CITY PLANNING COMMISSION

APPLICATION: 1. Environmental Determination
2. Plan Review to construct a 40,800 square foot warehouse on a portion of a 5.6± acre parcel in the Light Industrial-Review (M-1(S)-R) zone.

LOCATION: 3701 Pell Circle

P83-408

NORTH ELEVATION
SCALE: 3/8" = 1'-0"

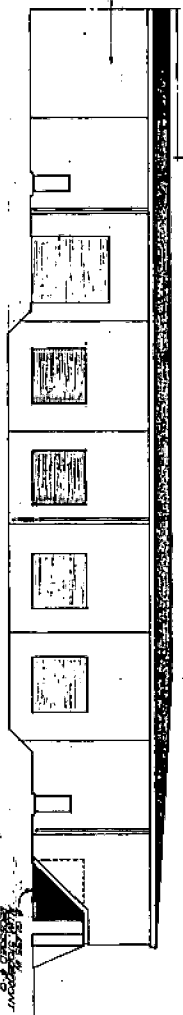
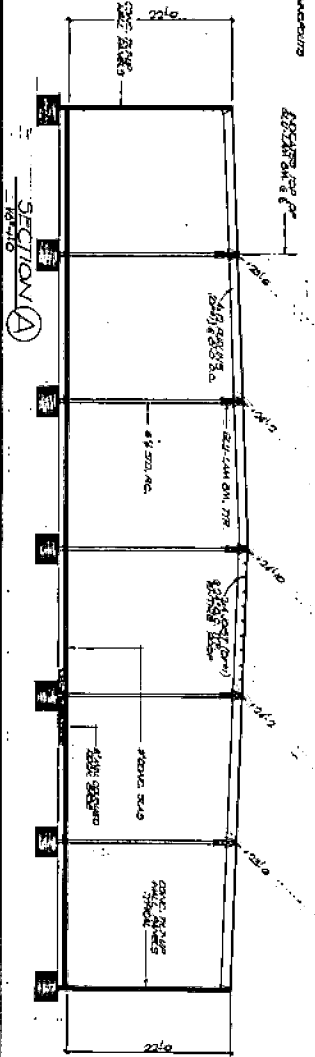
4. The elevation plans indicate the exterior building walls comprised of tilt-up concrete panels with the west and south building elevations (walls facing the public streets) consisting of a combination of rough exposed aggregate and smooth concrete finish. The large flat wall surfaces are broken up by recessed window and door openings with a strong eight-inch horizontal reveal band separating the aggregate surface from the smooth finish. To provide additional relief and variation to the large expanse of wall surface facing the public streets, it is suggested that several trees be planted in the planter strips adjacent to the west and south elevations.

The north and east elevations are constructed of smooth tilt-up concrete panels. The truck loading bays are located along the north face of the structure. Furthermore, it is suggested that a wing wall be constructed along the western-most loading bay to provide a visual screen to the rear docking area from the Pell Drive street view. The wing wall should be approximately nine feet in height (equal in height to match the height of the rough aggregate finish of the west elevation of the main building) and extend the length of the ramped loading bay (45± ft.). The surface of the wing wall should have the same rough aggregate finish as the main building. A second wing wall approximately the same size should be constructed along the eastern-most loading bay to provide a noise barrier to the residential subdivision to the east.

- 3) a screening wing wall shall be installed along the edge of the western most loading bay and along the northeasterly corner of the building as indicated in Exhibit A. The screening wall shall be nine feet in height, 45 feet in length and the west elevation shall be constructed of rough aggregate finish matching the aggregate surface of the main building;

LANDSCAPE PLAN

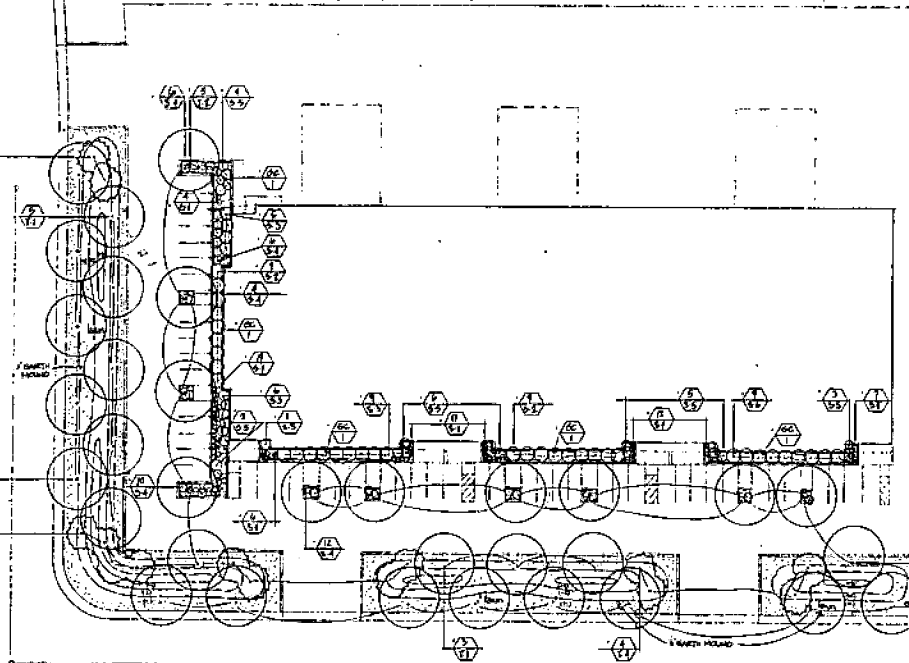
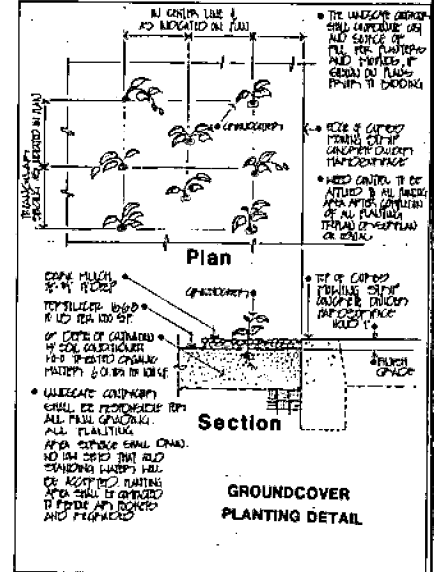
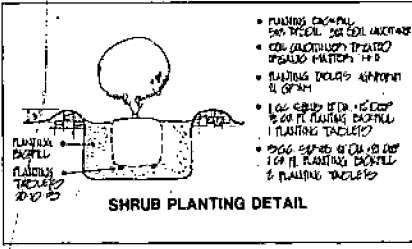
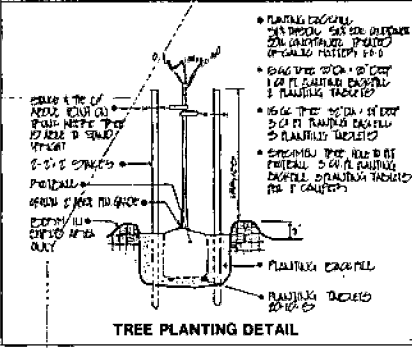
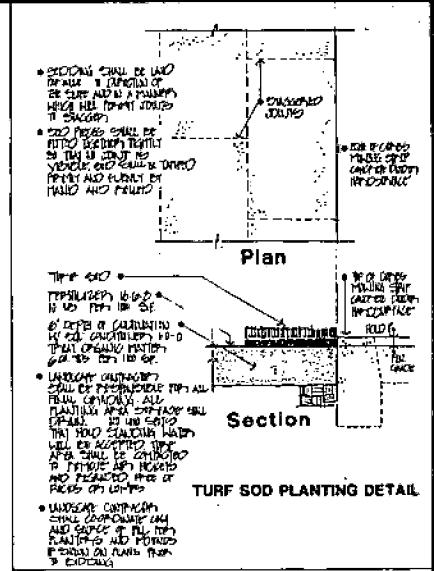
1. The subject site is zoned M-1(S)-R and designated industrial in the North Norwood Community Plan. The proposed project is consistent with the plan designation and zoning in that the applicant proposes to construct a 40,800 square foot, one-story warehouse structure on the subject site. Pursuant to the 'S' designation of the M-1(S) zone, the landscape plan indicates a 25-foot bermed landscaped setback adjoining the public right-of-ways.
2. The site plan shows eight 7 foot by 7 foot individual tree planters within the row of parking spaces adjacent to the building. Staff requests that individual planters be extended toward the building to connect with the planter strips located next to the building wall. This minor modification would provide additional surface area for landscaping and eliminate unusable asphalt surface area.

- a. The applicant shall submit detailed landscape and irrigation plans to the Planning staff for review and approval prior to issuance of building permit. The landscape plan shall include numerous plantings of 15 gallon trees along the west and south elevations of the building;

- 1) the eight individual tree planters located within the row of parking stalls shall be extended to connect with the planter strips abutting the west and south building wall;
